Roads Department – Planning Report

Register Reference: SD22A/0139 AI
Development: Removal of an existing totem signage pole and installation of a new three-sided, 3.34 metre tall, partially internally illuminated totem sign. Five non-illuminated new fascia signs on the south elevation of Unit 10 and all associated works.
Location: Unit 10, John F Kennedy Avenue, John F Kennedy Industrial Estate, Dublin, D12 NX74
Applicant: BOC Gases Ireland Ltd.
App. Type: Permission
Planning Officer: AOIFE O'CONNOR MASSINGHAM
Date Received: 19-Dec-2022
Decision Due: 25-Jan-2023

Figure 1: Extract from Dwg; MGS39042_EL_Rev6_3 - Proposed Elevations and Proposed Illumination of Totem Signage

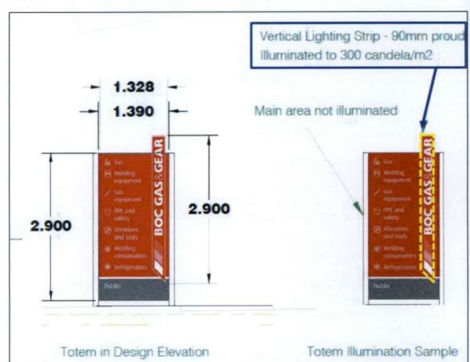
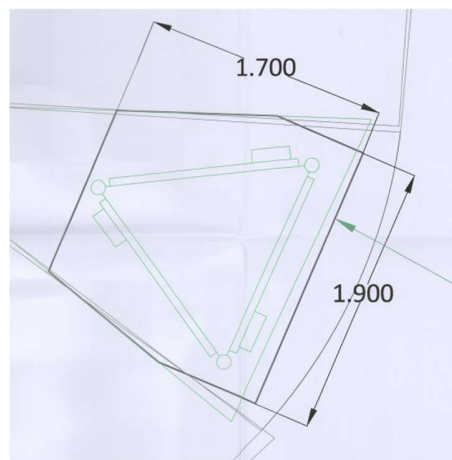
- Accurate plans and elevations of the proposed totem pole, including detail on the proposed materials and illumination. Drawings should include all key measurements, including the height of the sign and the depth of any projecting elements.

The proposed elevations below show that the vertical strip on the totem (highlighted with a yellow dashed line) will be internally illuminated, and the rest of the sign will not have any illumination. The proposed elevations also show the dimensions of the proposed totem signage.

Details re materials and lumination are satisfactory to the Roads Department.

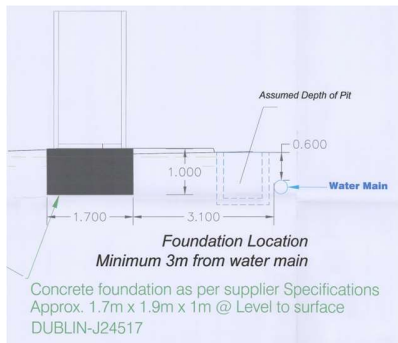
- A structural drawing which details the totem signage foundation and structural make-up.

Foundation details are satisfactory to the Roads Department.
